APPLICATION FOR SUBMITTAL OF POST-APPROVAL DOCUMENT

South El Monte High School Modernization

CCD-21

Project Reference: South El Monte High School Modernization Date: 11/21/2023

MECHANICAL REMODEL ROOF PLAN - BLDG L

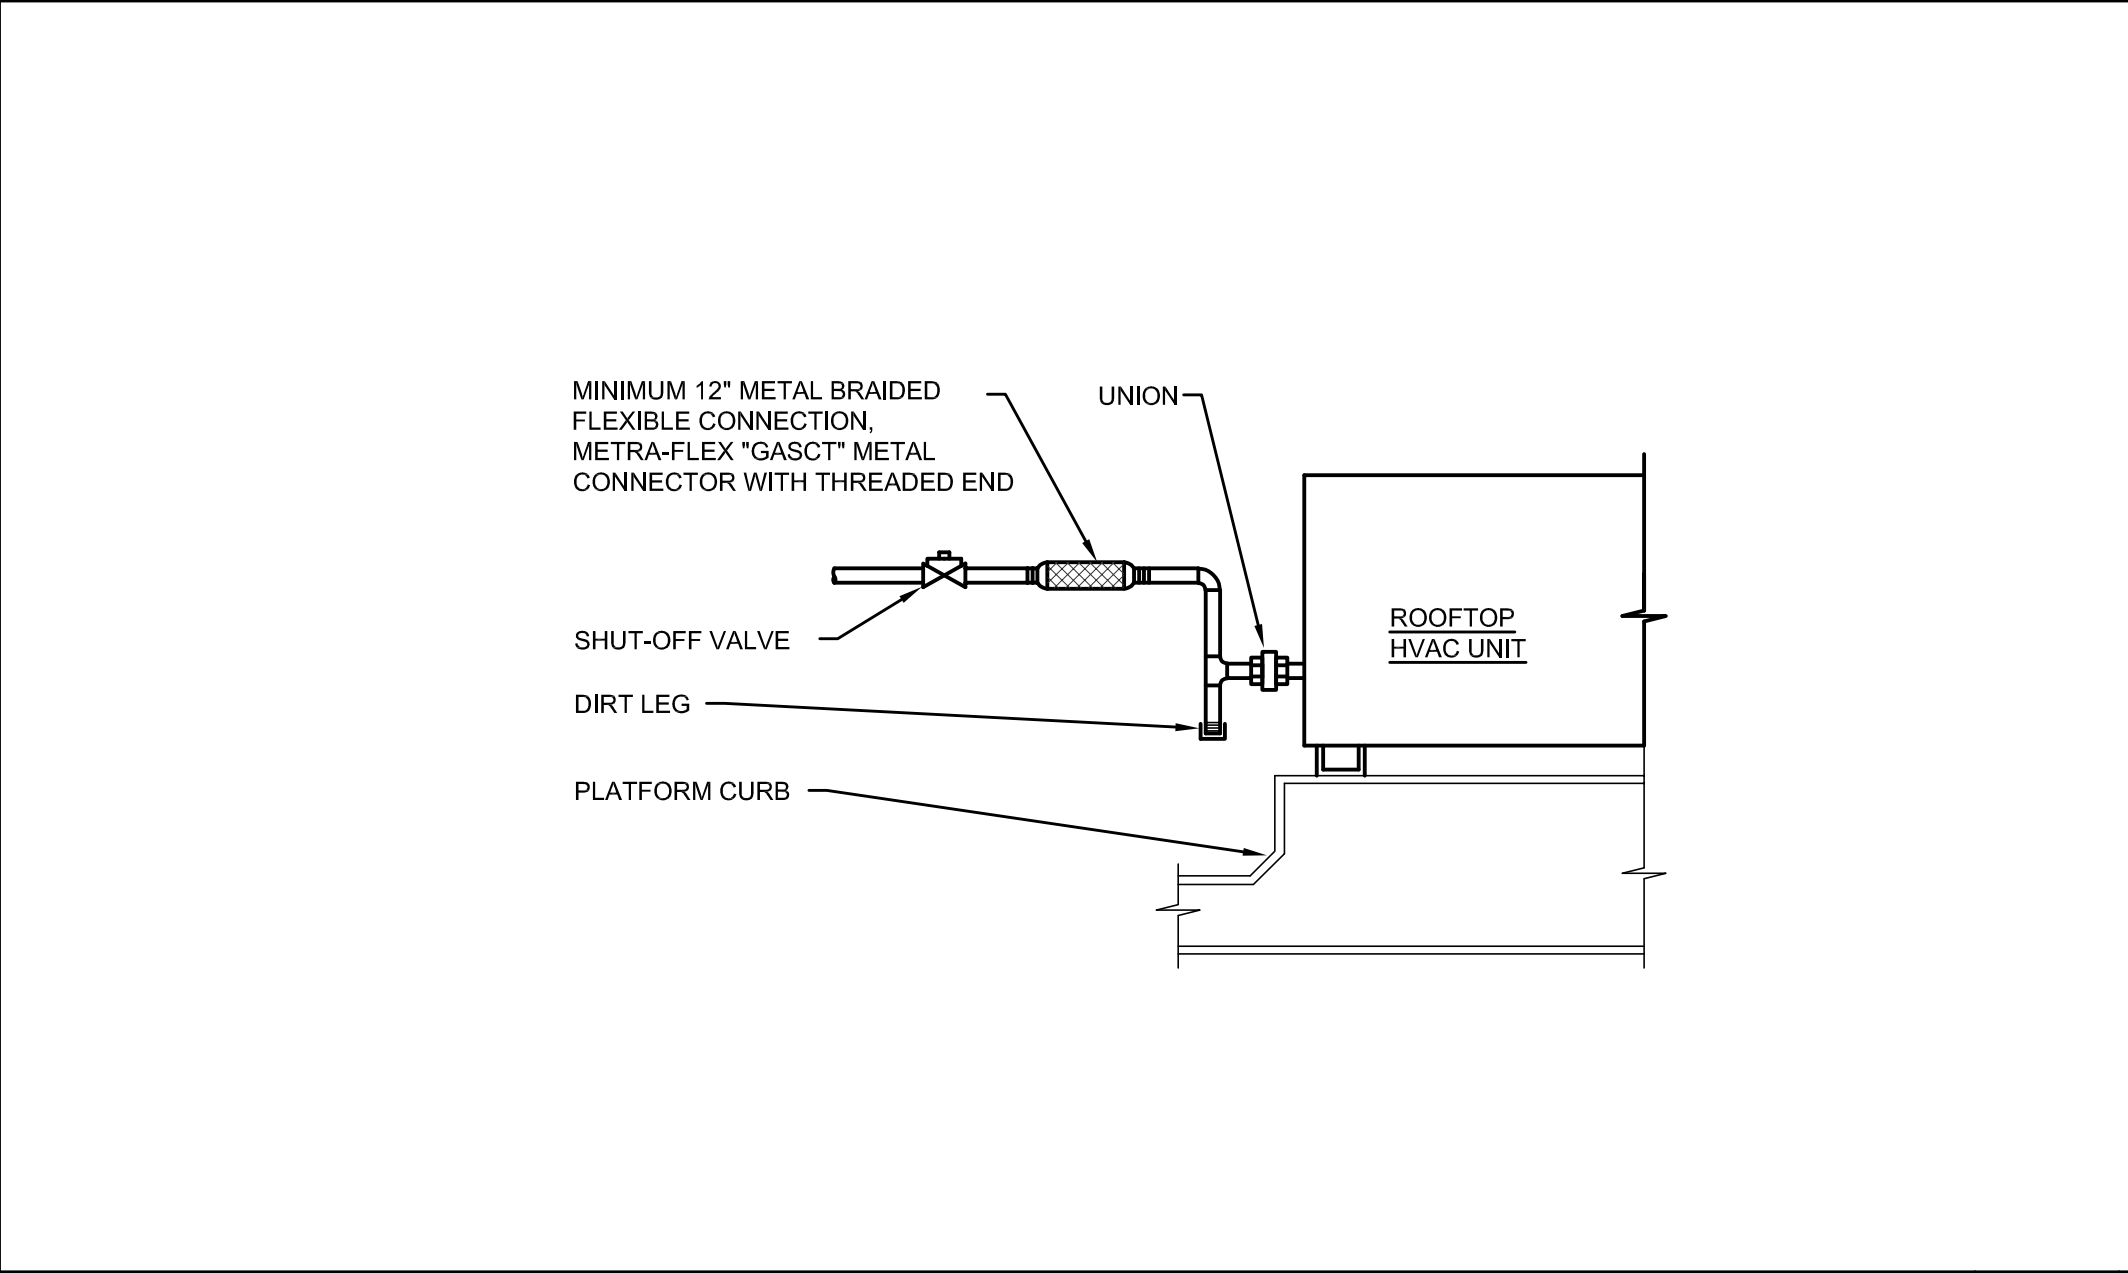
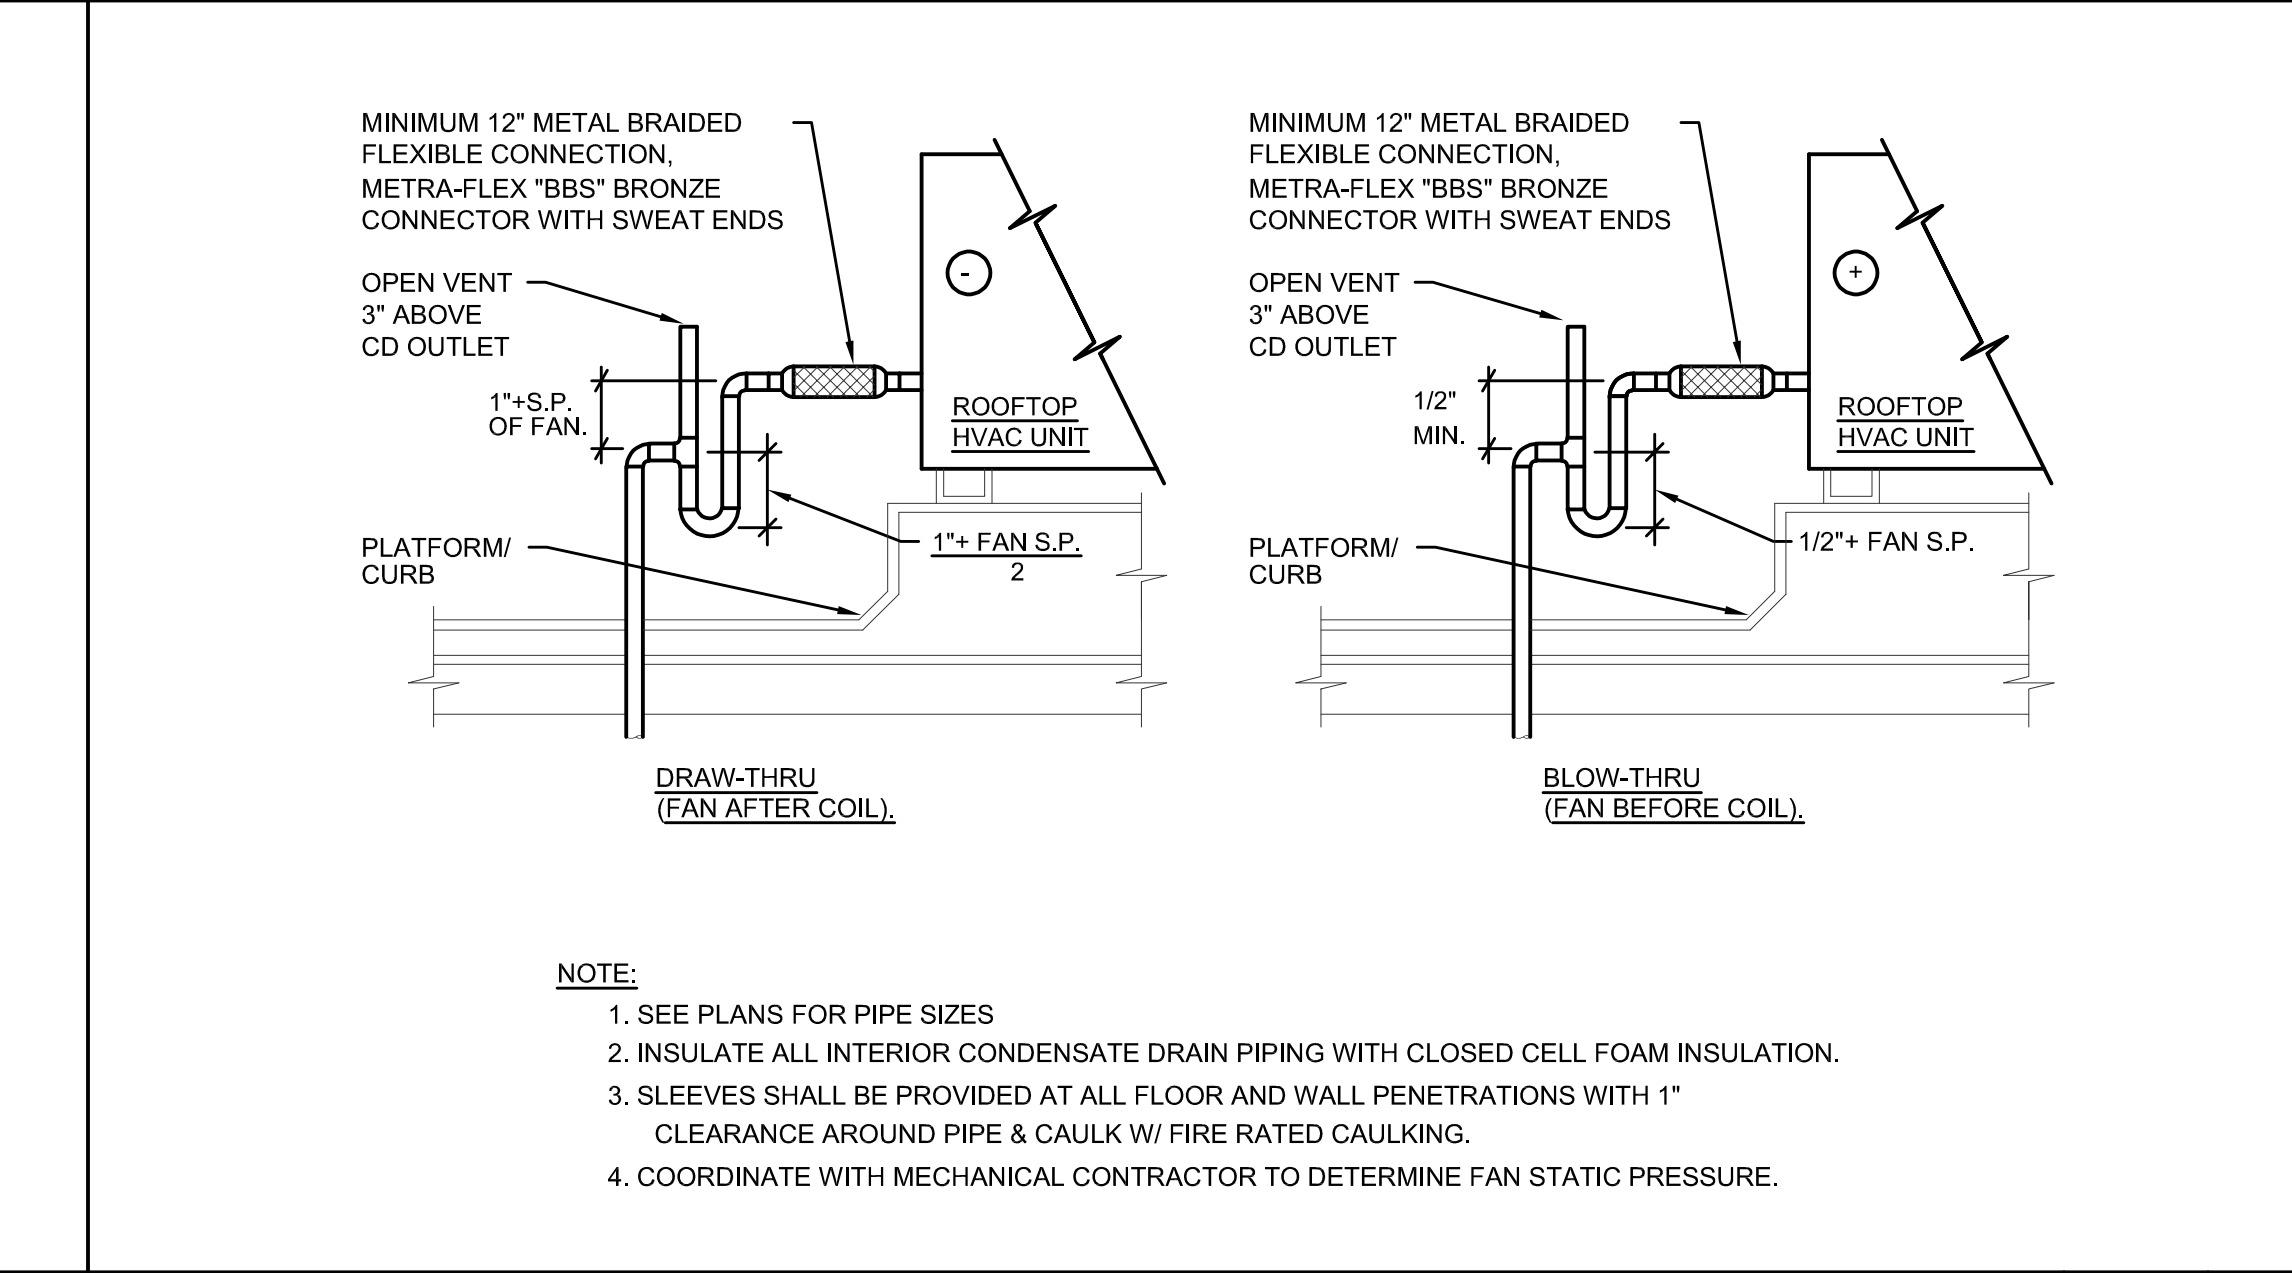
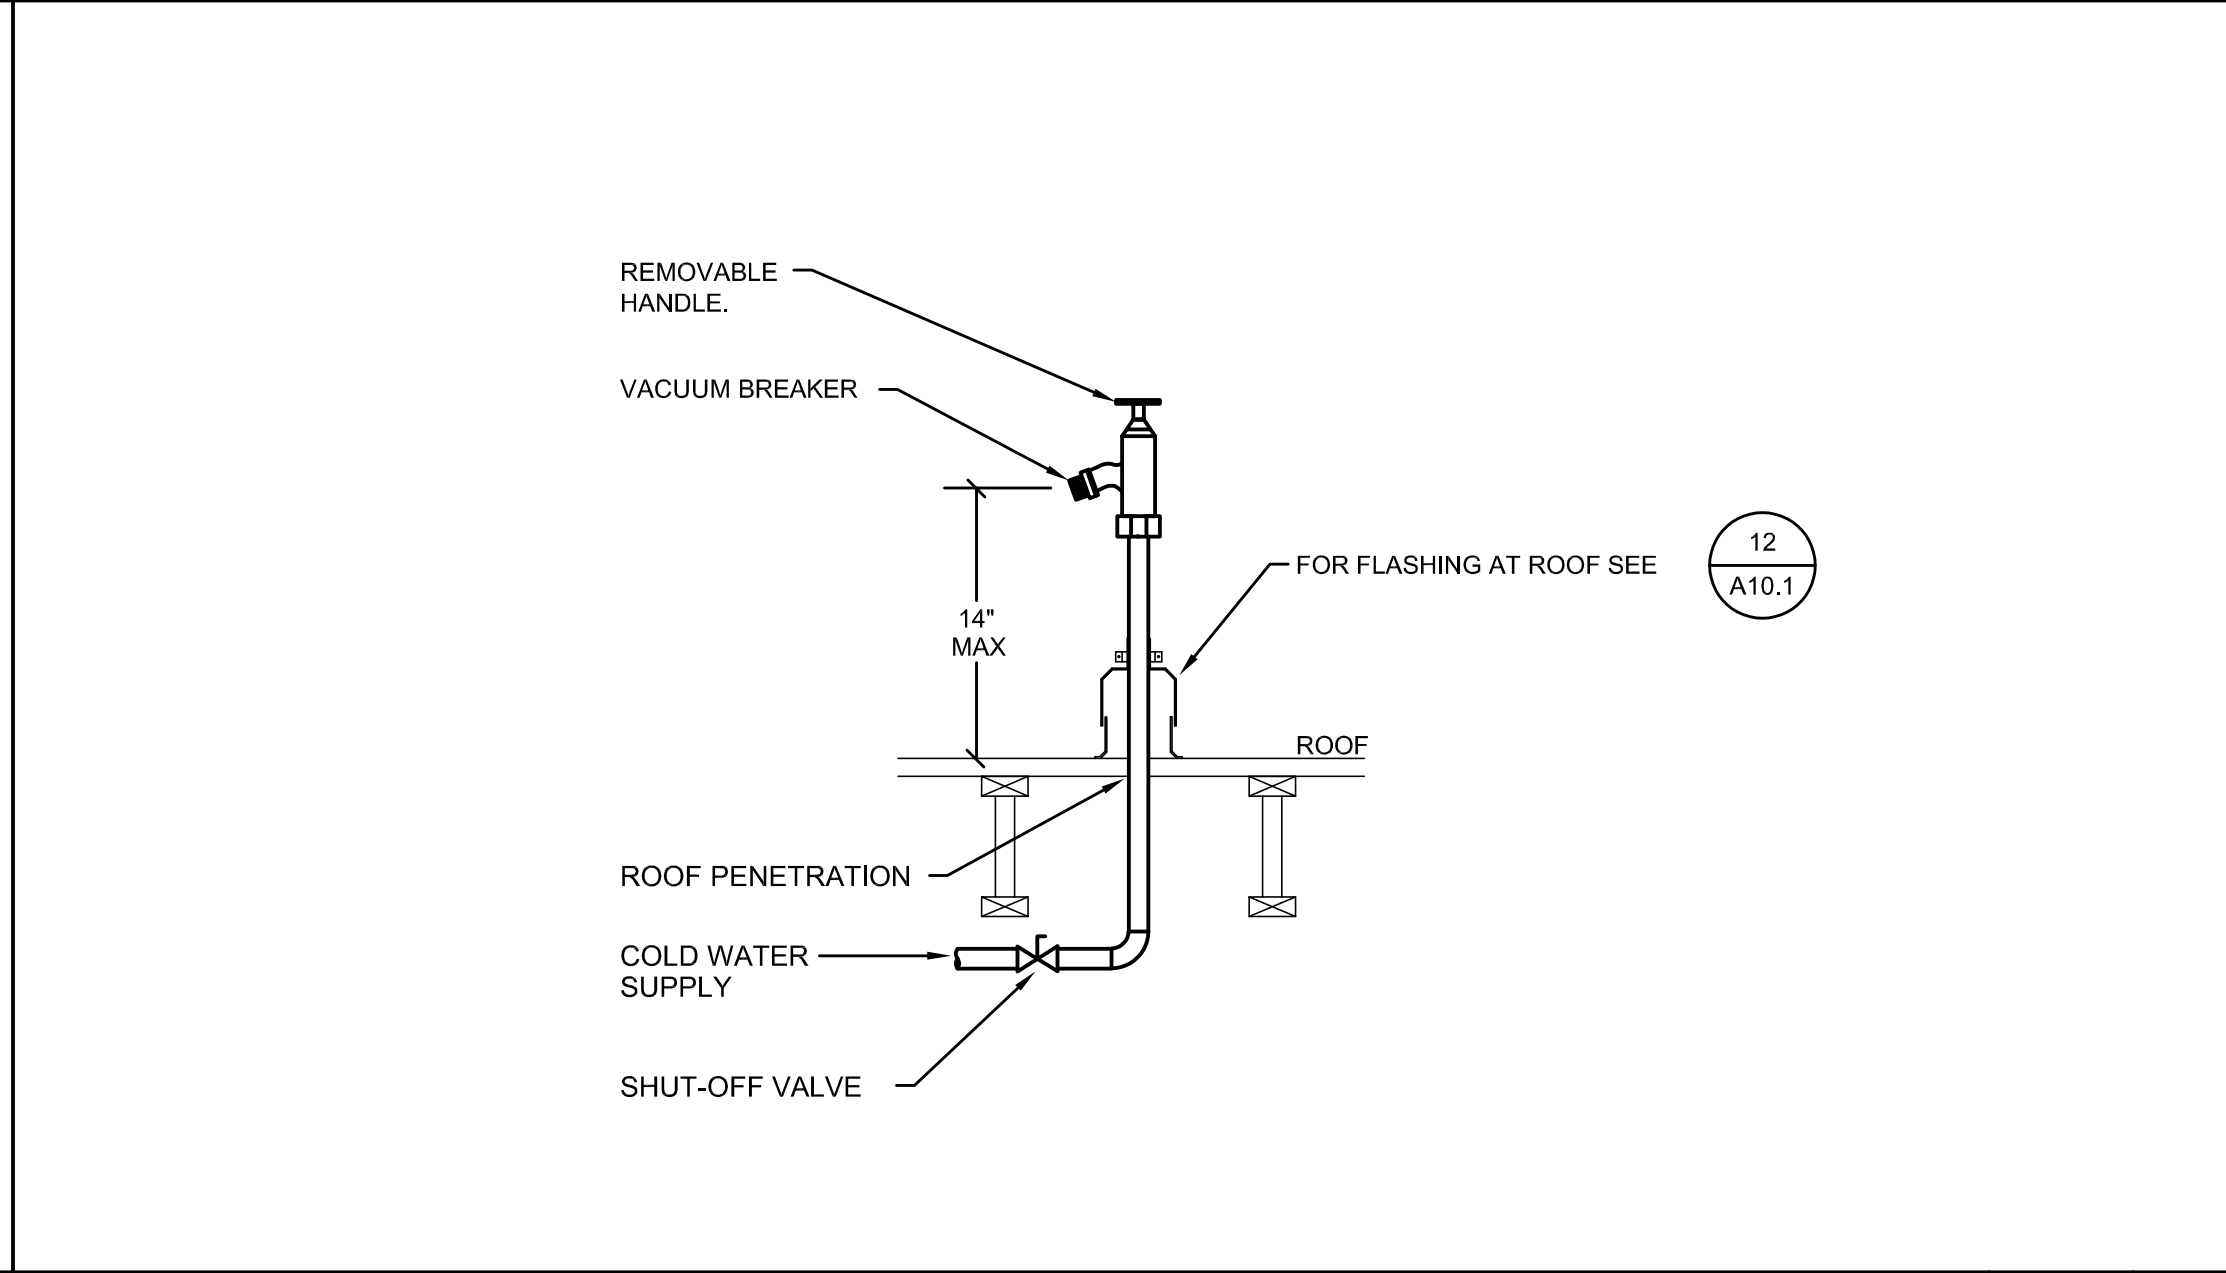
- 21.9. SHEET M3.L1 – MECHANICAL REMODEL ROOF PLAN – BLDG L**
21.9.1. New sheet provided to identify new RTU replacement units on the roof above the existing food service area. Units will replace existing units as noted.
